TUTHILL SUBDIVISION, PHASE I

APPLICATION NUMBER 9 DATE May 5, 2011
APPLICANT Tuthill Subdivision, Phase I
REQUEST Subdivision

DETAIL SITE PLAN

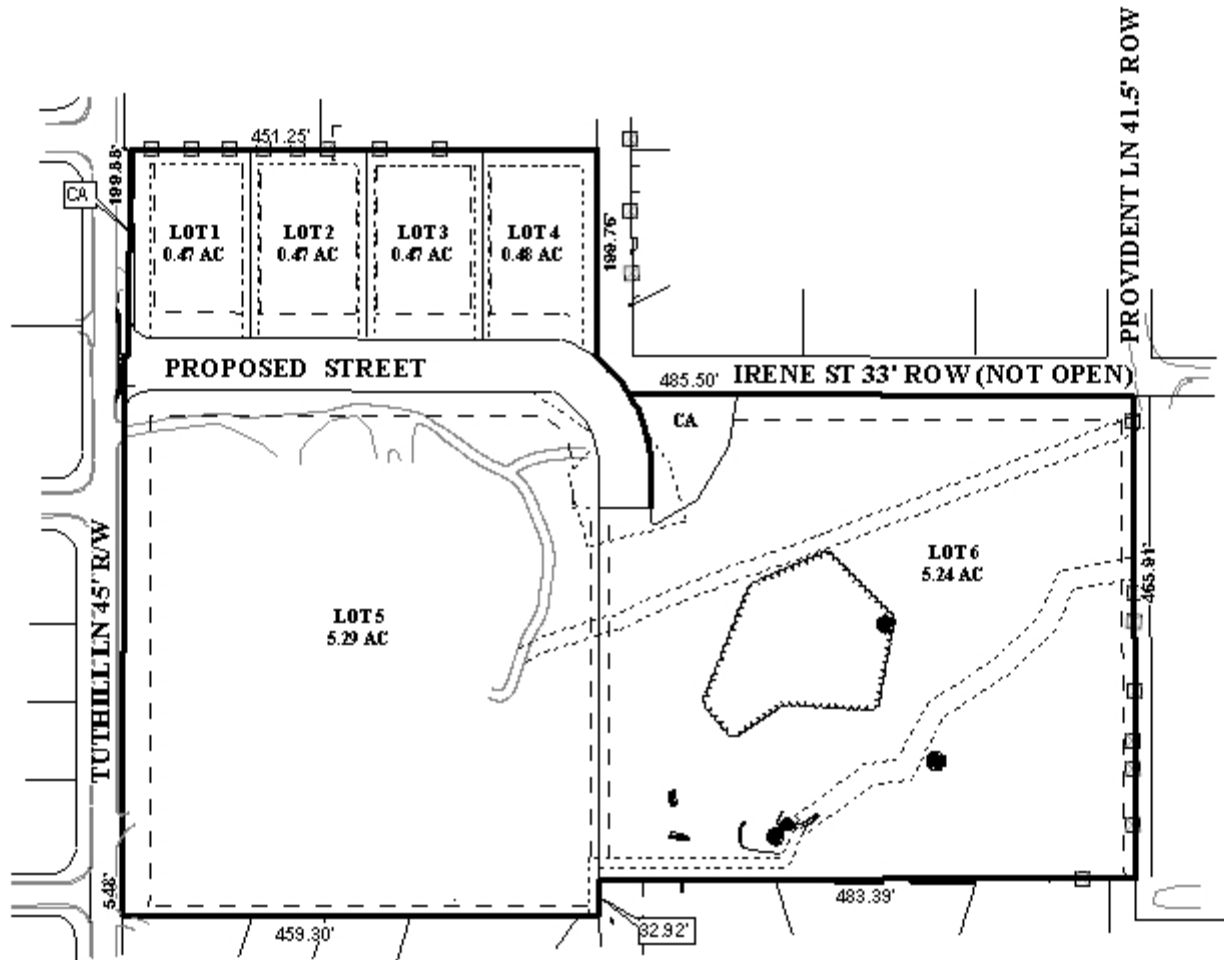
Access management is a concern due to the increase in the number of residential lots. Proposed Lots 1-4 should be limited to one curb-cut each onto the improved Irene Street, and denied direct access to Tuthill Lane and any adjacent unimproved rights-of-way. Lot 5 should be limited to its two existing curb-cuts onto Tuthill Lane, and two curb-cuts onto Irene Street. Lot 6 should be limited to one curb-cut onto Irene Street, and denied access to any adjacent unimproved rights-of-way.

As part of the Phase 1 development, the applicant proposes to create a temporary gravel turn-around with an associated easement. Any use of gravel for the turn-around should be approved by the Engineering and Fire-Safety Departments, including the proposed 93-foot diameter size. For Phase 2, the applicant proposes to extend the road and create a permanent turn-around or cul-de-sac, however, they do not have a specific time-frame for Phase 2. If Phase 2 does not materialize, development of Lot 6 should be prohibited until a permanent cul-de-sac meeting the minimum 120-foot right-of-way diameter requirement of the Subdivision Regulations is constructed, and a revised plat is approved and recorded showing right-of-way necessary for a cul-de-sac.

It should be pointed out that proposed Lot 6 has significant topographic changes which create severe storm water drainage issues. As such, there are several drainage easements across the lot. Furthermore, there is a large utility easement that crosses the proposed lot.

The 25-foot minimum building setback line, required in Section V.D.9., is shown for the subdivision, however, it should be relocated if dedication along Tuthill Lane is required.

A Detention basin common area as well as another common area, are proposed for the subdivision. A note should be placed on the Final Plat, if approved, stating that maintenance of the detention basin common areas, and any other common areas, are the responsibility of the subdivision's property owners.

Regarding the common area proposed along Tuthill Lane, if the applicant intends to build a wall or fence in this area, full compliance with the requirements of the Zoning Ordinance will be necessary. Building permits will be required for any walls or fences erected on the site.

Large oak and other species of trees are depicted on the preliminary plat. Tree protection barriers should be provided during construction a minimum of 10-feet from the trunk of any tree that receives preservation status from Urban Forestry.

- 1) Dedication of right-of-way along Tuthill Lane to provide 25-feet, as measured from the centerline, and revision of the 25-foot setback line to reflect any dedication;

- 2) Construction the proposed Irene Street to city standards, with the temporary turn-around to be approved by Engineering and Fire-Rescue;
- 3) Placement of a note on the final plat stating that Lots 1-4 are limited to one curb-cut each to Irene Street, and are denied direct access to Tuthill Lane and any other adjacent unimproved rights-of-way, that Lot 5 is limited to its two existing curb-cuts onto Tuthill Lane and two curb-cuts onto the proposed Irene Street and denied access to adjacent unimproved rights-of-way, that Lot 6 is limited to one curb-cut onto the proposed Irene Street, and denied access to adjacent unimproved rights-of-way, with the size, design and location of all new curb-cuts to be approved by Traffic Engineering and conform to AASHTO standards;

- 4) Placement of a note on the final plat stating that development of Lot 6 is prohibited until such time as a permanent paved turn-around or cul-de-sac meeting City standards is provided;

- 5) Labeling of all common areas, including detention areas, and placement of a note on the final plat stating that the maintenance of the detention common areas is the responsibility of the property owners;

- 6) Compliance with Engineering comments (*Must comply with all storm water and flood control ordinances. Detention must be provided for all proposed roadway improvements and for the projected development of Lots 1-4. The receiving drainage system on the unopened Irene Street ROW is currently inadequate to receive an increase in runoff, so the proposed detention system and release shall be designed to accommodate this condition so that downstream properties are not adversely affected. The alignment of the proposed 15" RCP needs to be revised so that the pipe is crossing the roadway*

perpendicularly, therefore another drainage structure will be required. A drainage easement and an approved & adequate drainage conveyance system along the rear portions of Lots 1-4 and along the eastern lot line of Lot 4 is required to capture and convey runoff from the properties to the north as well as drainage from the proposed Lots 1-4 so as to not inundate the properties located to the east at Springhill Court subdivision. The maintenance of this easement needs to be clearly stated on the plat that it is the Property Owner's Association's (POA's) responsibility to maintain. There may need to be additional measures implemented along the eastern property line of Lot 4 so as to prevent flooding of properties located at 3 & 4 Spring Hill Ct. Drainage cannot be concentrated onto an adjacent property without a release agreement from the affected downstream property owner(s). The acceptance of the temporary gravel turnaround subject to Fire Department approval. Drainage from the roadway does not need to discharge onto this temporary turnaround and needs to be routed to the detention pond to reduce required maintenance. Add a note to the plat that the maintenance of the temporary turnaround is the responsibility of the POA and not the City of Mobile. Any work performed in the right of way will require a right of way permit in addition to any required land disturbance permit.);
